STILLWATER - DOUBLE CREEK PHASE 2

**10801 BREZZA LN
SP-2021-0178C**

VARIANCE REQUEST

CRITICAL WATER QUALITY ZONE

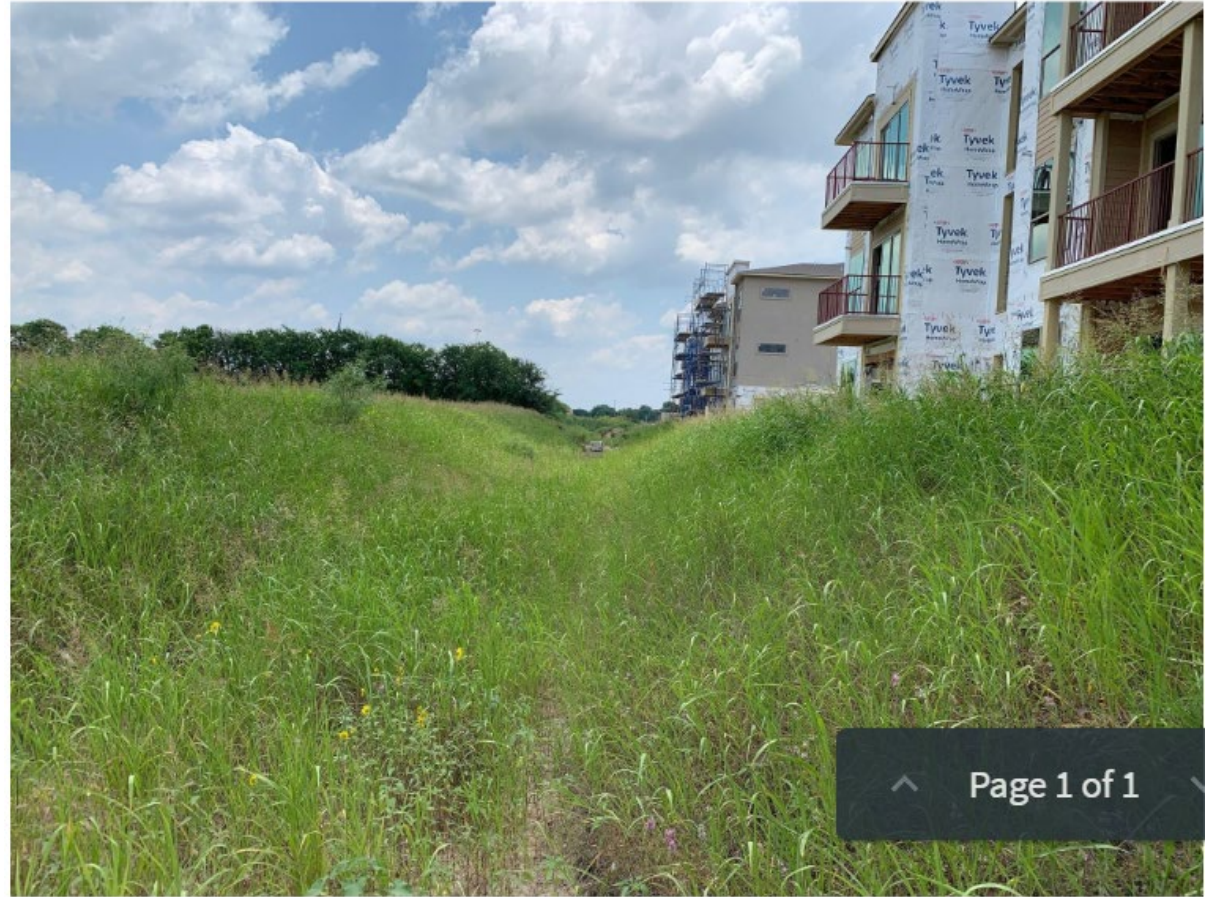
The request is to vary from Land Development Code 25-8-261 to allow development in the critical water quality zone for a driveway over the critical water quality zone in order to meet the health and safety requirement of having two points of ingress/egress as set by Austin Fire Department.

Staff recommends approval of the variance with the following conditions:

- 1) Internal, low-traffic pedestrian walkways throughout the site shall be constructed with permeable pavers or porous pavement in accordance with the Environmental Criteria Manual. This will decrease overall impervious cover and increase stormwater infiltration onsite and baseflow in the stream channel.**
- 2) The critical water quality zone shall be crossed with a span bridge design instead of the normal box culvert. This will reduce the bridge's footprint in the channel and allow for light to penetrate to the natural ground surface and for vegetation to grow thus maintaining a more natural stream channel.**
